Agenda Item #2

Application 2024-29-CA

7 Hannon Avenue

Remove and replace existing siding with fiber cement lap siding. Replace windows on all elevations except those on the façade and two windows on rear addition.

Site Photos – 7 Hannon Avenue

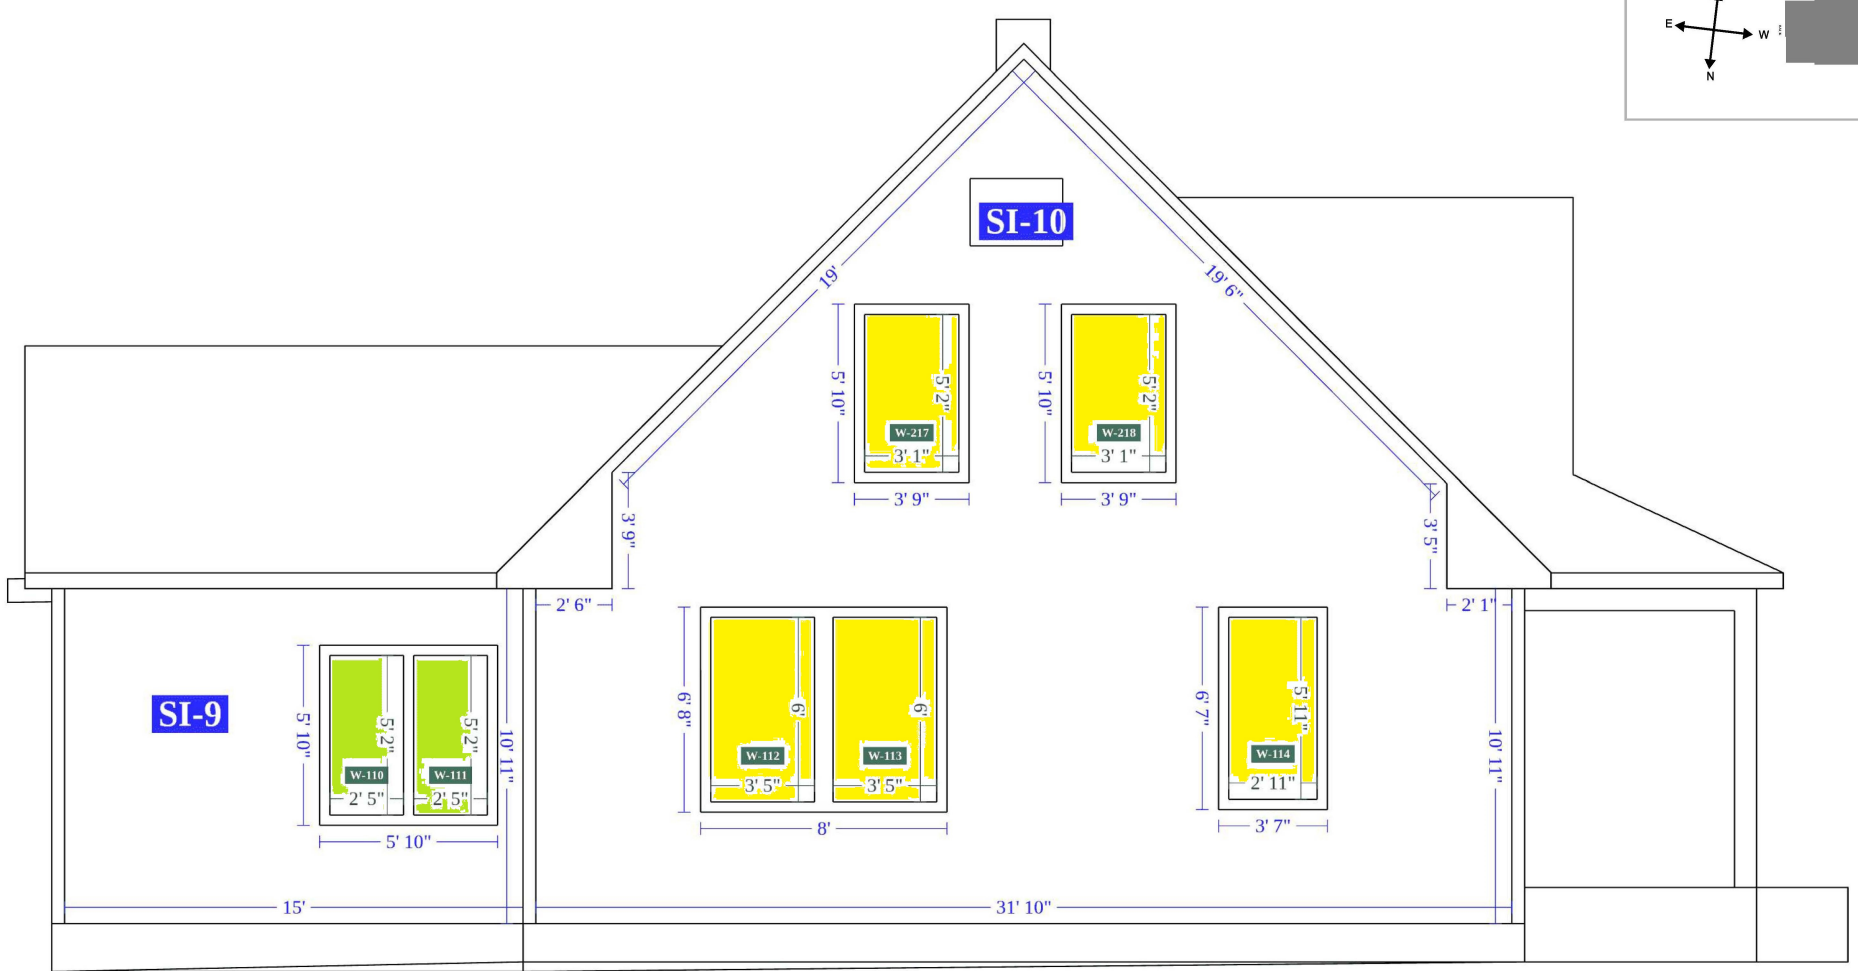
1. View of west façade, looking east. Note wood drop siding on façade and asbestos siding in center gable.

2. View of south elevation, looking northwest. Note asbestos siding on original block and fiber cement on one-story rear addition.

3. View of rear (east) elevation, looking west. Note fiber cement siding on flat roof portion and asbestos siding on gable cross-wing.
